Access Compliance Report

Public Rights-of-Way

(Curb Ramps)

Intersection ID: 30206	Main Street: COY_CT	Cross Street: PATRICIA_RYAN_DR	Location: SW
ADA ID: F8504DBB6F78	Ramp Type: Perp	Initial Pass/Fail: Fail	Overall Compliance: No
		Severity Score: 8.75

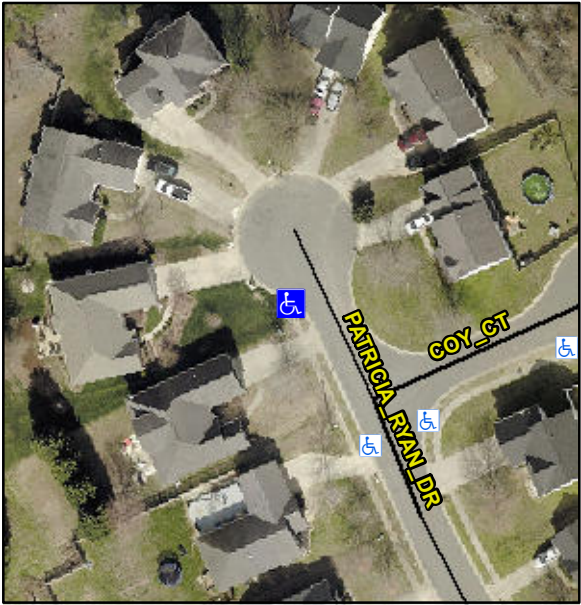
Codes/Mitigation Info/Possible Solution			Field Measurements/Component Compliance		
	Possible Solutions:		Compliance	Description	Data
	Remove & Replace Entire Ramp.		Yes	Ramp Length (in)	48.5
			No	Ramp Width (in)	38.5
			N/A	Flare Type LT	N/A
			N/A	Flare Slope LT (%)	N/A
			N/A	Flare Traversable LT?	N/A
			N/A	Landing Length (in)	N/A
			N/A	Landing Width (in)	N/A
			N/A	Landing Slope (%)	N/A
			N/A	Landing X Slope (%)	N/A
<p>Surveyor Notes:</p> <p>N/A</p> <p>PROW/ADA:</p> <p>R304.5.1</p>			N/A	Flare Type RT	N/A
			N/A	Flare Slope RT (%)	N/A
			N/A	Flare Traversable RT?	N/A
			N/A	DWS Provided?	N/A
			N/A	DWS Contrast?	N/A
			N/A	DWS Length (in)	N/A
			N/A	DWS Full Width?	N/A
			N/A	DWS Offset (in)	N/A
			N/A	Shared Landing?	N/A
			N/A	Gutter Ponding?	N/A
			N/A	Gutter Lip Ht (in)	N/A
			No	Painted X Walk1?	N/A
				X Walk 1 Direction	To N
			N/A	X Walk 1 Width (in)	N/A
				X Walk 1 Slope (%)	3.7
				X Walk 1 X Slope (%)	3.2

N/A	Ramp inside XWalk1?	N/A
			N/A	Road Slope (%)	3.2
			N/A	Road X Slope (%)	3.7
			N/A	Any Obstructions?	N/A
				Obstruction Type	
			N/A		
			N/A		
			N/A		
			N/A		
			N/A		
			N/A		
			N/A		
			N/A		
			N/A		
Total Cost:		\$ 1850.00			
			N/A		
			Yes	Surface Condition? (G/P)	Good
